# New South Vashon Levy Trailhead Project and Trail System Improvements Questions from the Community

Updated March 2026

This document addresses comments and questions submitted by the public during the State Environmental Policy Act (SEPA) public comment period and other public outreach efforts for the South Vashon Trailhead and Trail System Improvements project. In 2023, King County Parks and Recreation acquired approximately 50 acres of property on Vashon Island (Parcels 0121029003, 0121029137, 0121029002, 0121029121, 0121029122, 0121029123 and 0121029055). The property is mostly forested and has not been developed other than non-motorized trails. The purpose of the acquisition was to allow public access to the 50 acres that will become a new park.

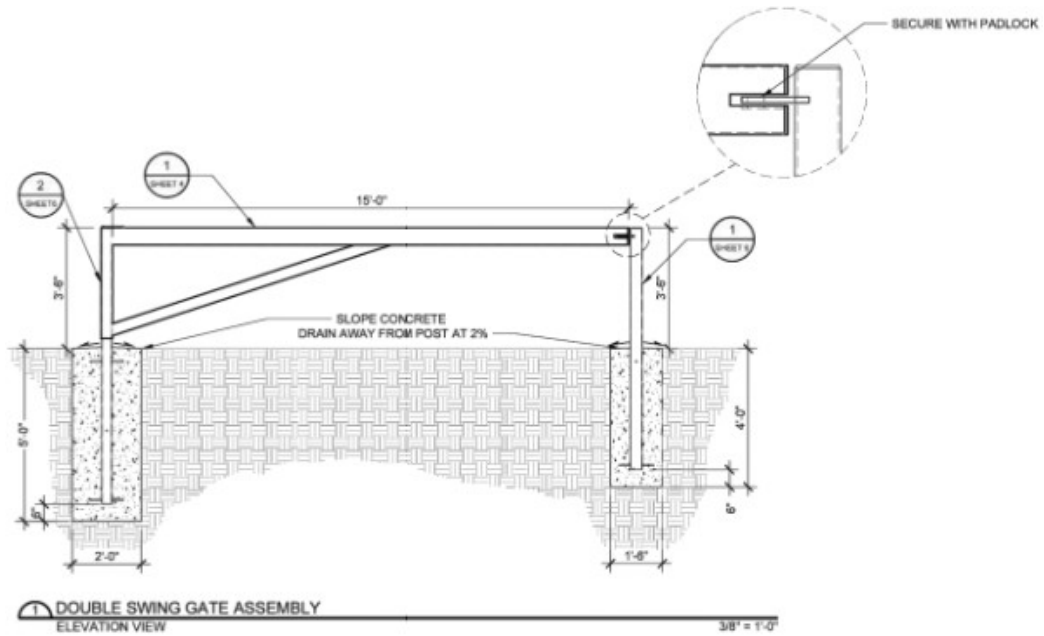
### **Will the existing trail along the eastern edge of the property be maintained?**

The trails along the eastern edge of the property are planned to be retained.

## SIGN LAYOUT AND INSTALLATION

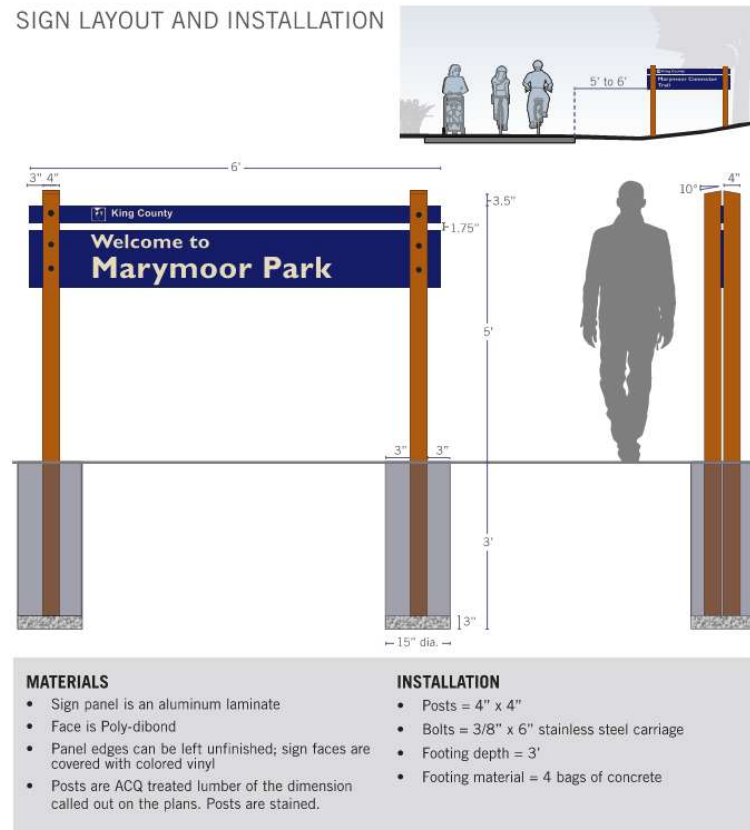
**What entry sign will be provided?**

All King County Parks use the same entry sign standard so that they may be consistently maintained. As shown on the detail below, the sign is approximately 3.5 feet tall and is intended to provide consistent visual cues for King County Parks properties across the county while being minimally intrusive in the surrounding natural habitat.
